February 13, 2023

**RE: Newton Park Tennis Complex Improvements  
EOS Project No. PV-2111**

**ADDENDUM No. 1**

Dwg No C4.0:

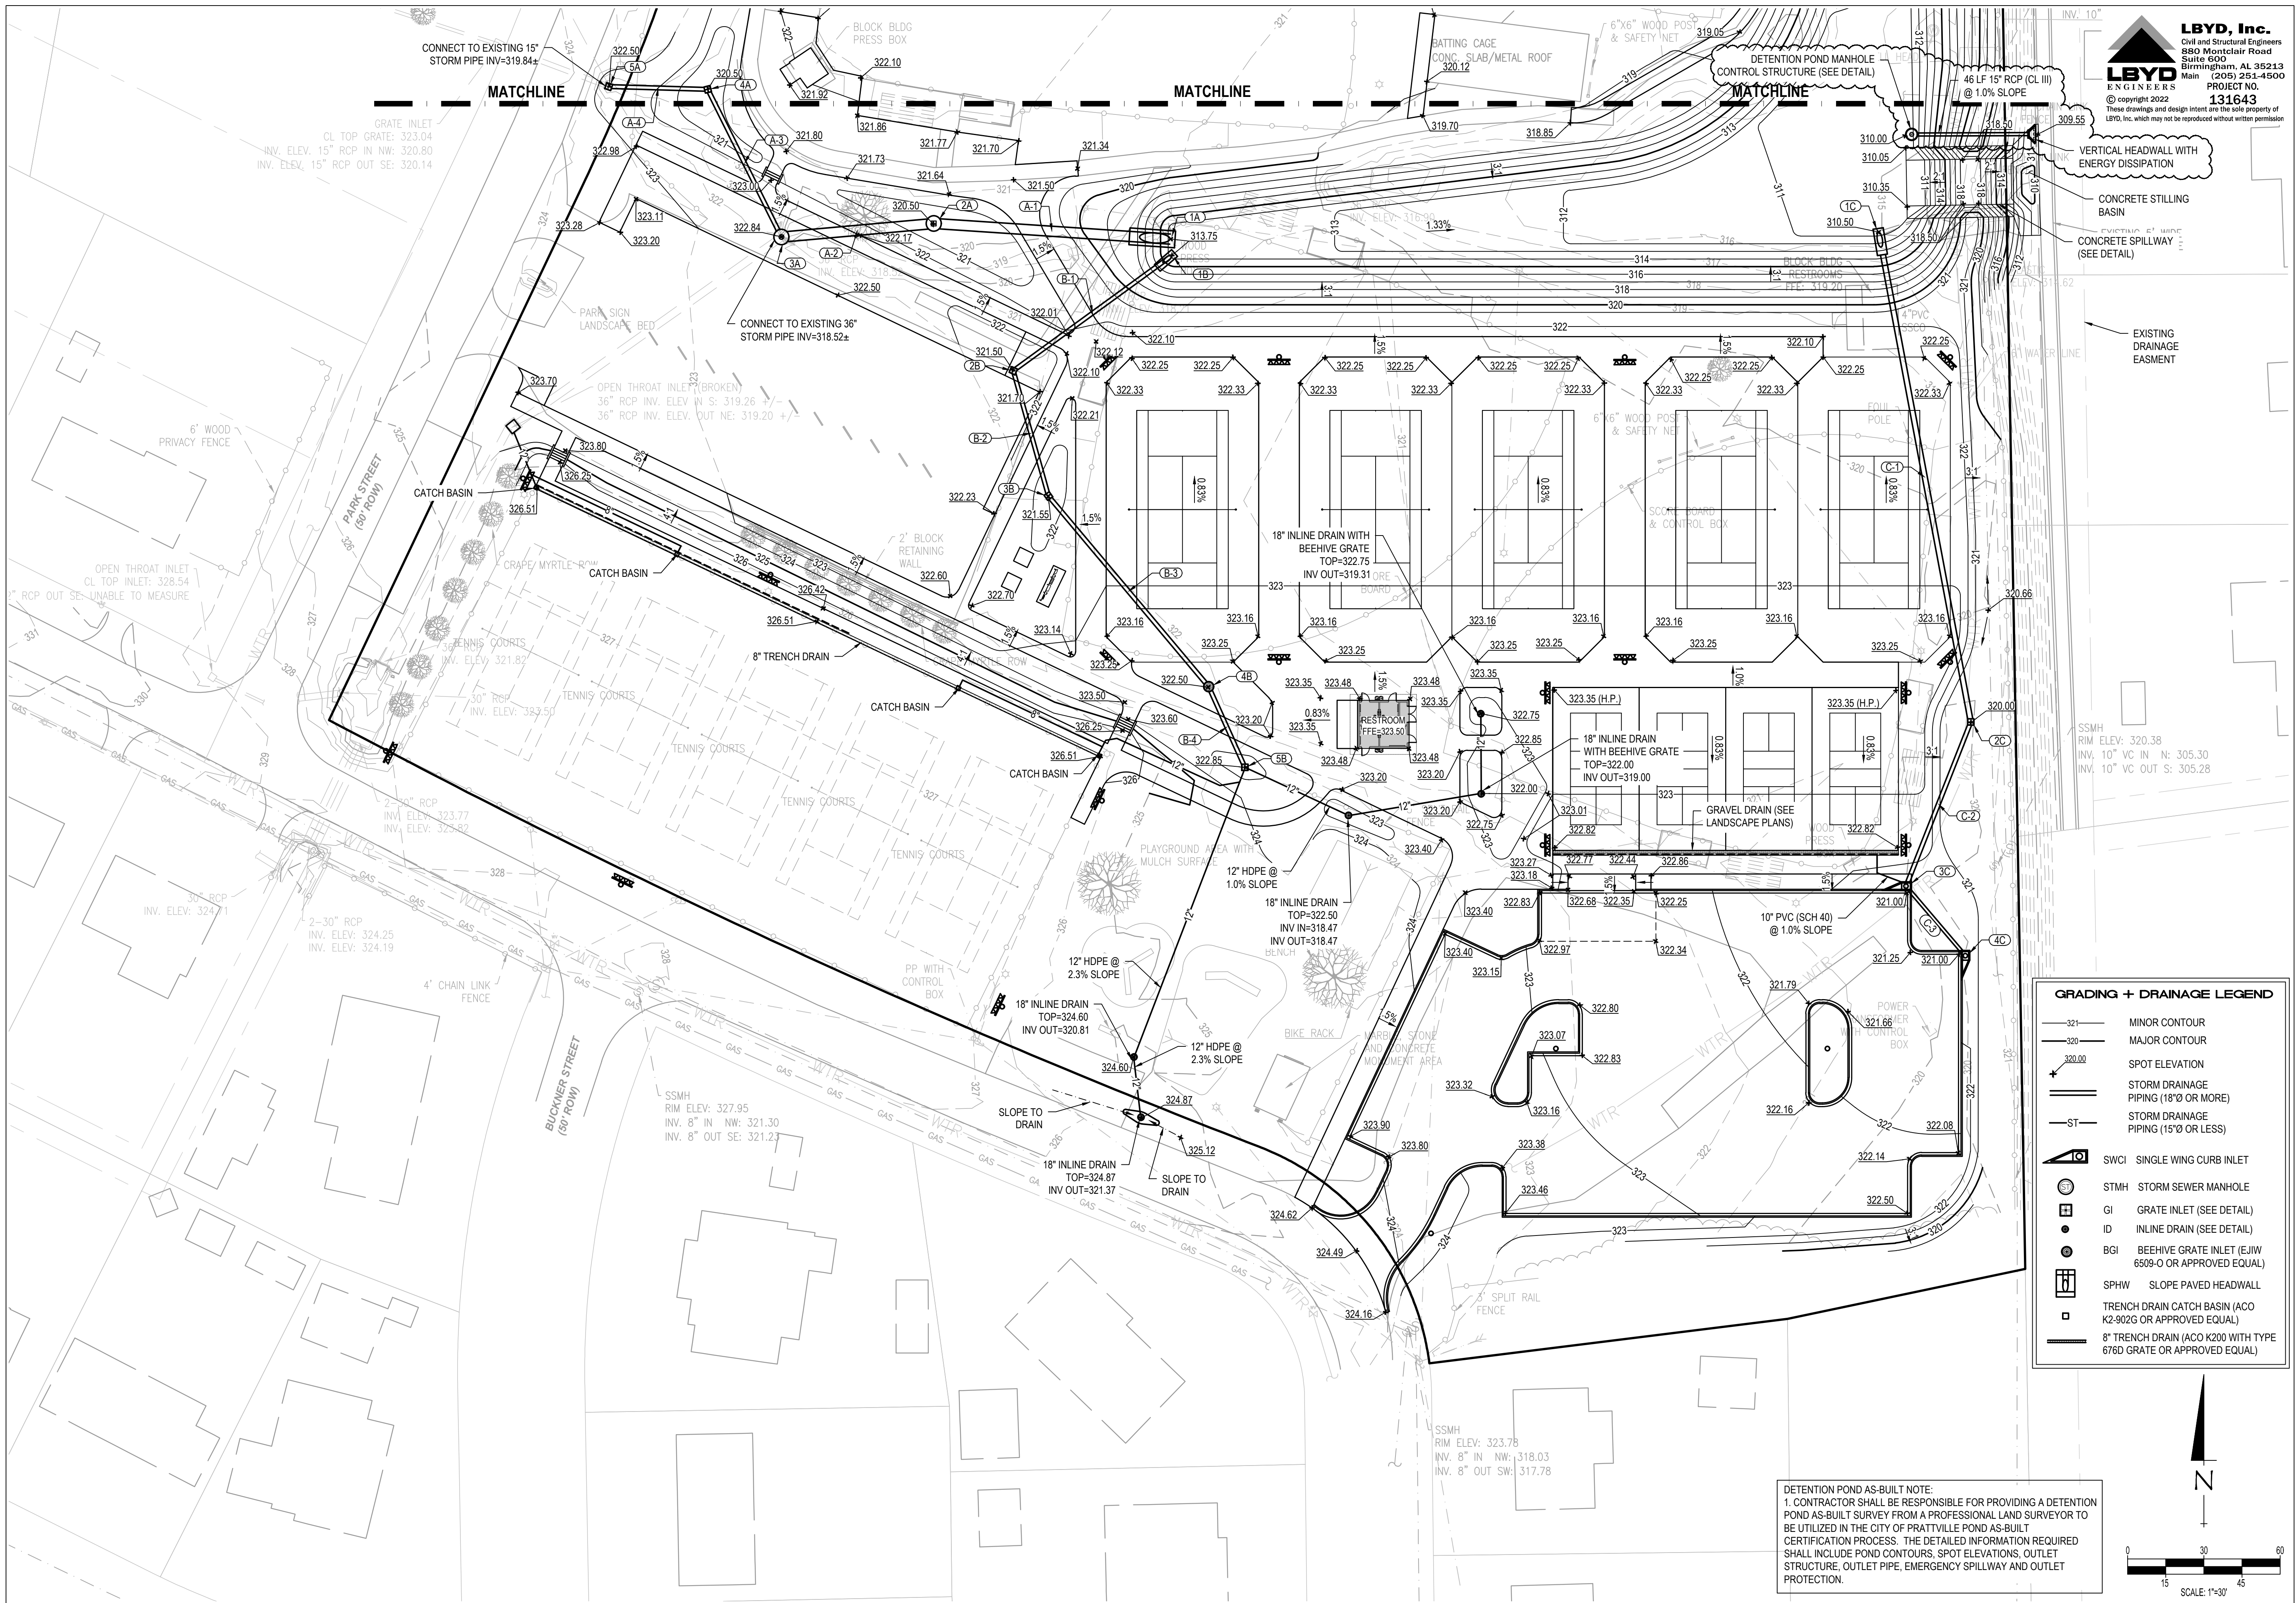
1. Delete in its entirety and replace with the attached.
